October 28, 2021

FROM: Jillian Dierks, Planner, Department of Building and Planning

SUBJECT: PRELIMINARY LAND DEVELOPMENT PLAN – 75 St. James Place & 119, 121, 123, 125 & 127 Coulter Avenue, Suburban Square, LD# 3782, Ward 5.

Easternmost Portion of the South Elevation

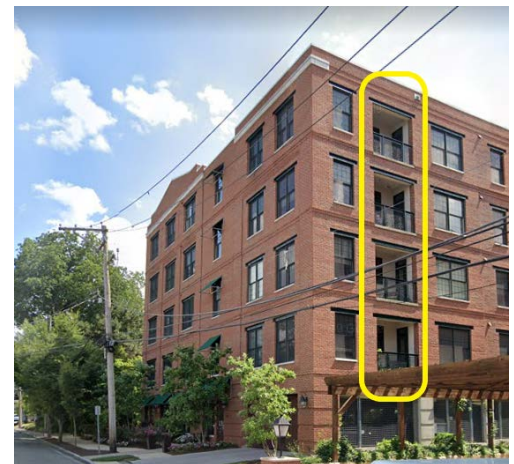
- Easternmost Portion of the South Elevation & East Elevation: Staff and the County both commented on architectural treatment of the easternmost portion of the South elevation. The revised elevations include additional glazing. As noted above staff feels that the eastern property boundary presents an opportunity to allow for more outdoor space. An increased setback will also allow for fenestration along this elevation. Staff has included a condition requiring the applicant to work with staff on the building massing along the east elevation.

- Rear Building Detailing: The Planning Commission commented on the detailing of the rear elevation. The rear elevation has been further refined and staff has included a condition of approval requiring the applicant to investigate incorporating architectural elements such as recessed or protruding balconies along the rear elevation to add visual interest.

- Use of Grey Coloring: Following the Planning Commission meeting staff spoke with the applicant about the brick selection and the applicant began exploring alternatives to the grey brick proposed. Staff has included a condition of approval requiring the applicant to continue to work with staff to utilize a brick color that is complementary to the surrounding neighborhood.
